# UNITED STATES PATENT AND TRADEMARK OFFICE

10/730,297

<b>Office Action Summary</b>	Application No. 10/730,297	Applicant(s) ROMANO ET AL.	
	Examiner Michael G. Bogart	Art Unit 3761

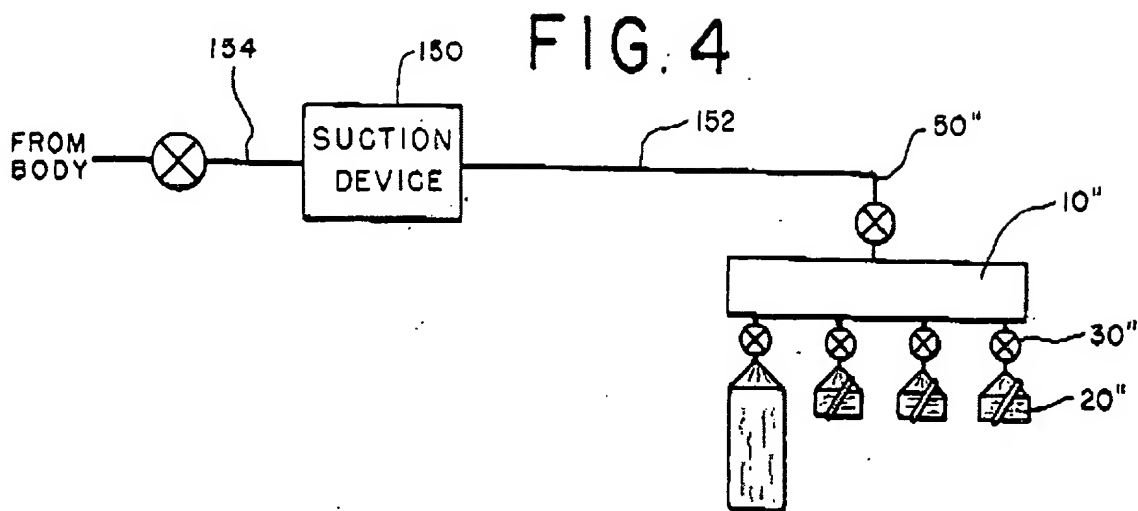
d) sealing a vacuum draw path (152) with said container (20) by coupling said path (152) with a fluent material waste collection system (150, 152, 154, 50, 10) and said container (20),

e) drawing said fluent material waste into said container (20),

f) unsealing (40) said path by disconnecting said container (20) from said vacuum draw path (152) and said waste collection system (150, 152, 154, 50, 10),

g) sealing said container (20) with a closure (40) for containment and disposal of said fluent waste material (Abstract; col. 4, lines 16-50; col. 6, lines 37-48)(figure 4, *infra*).
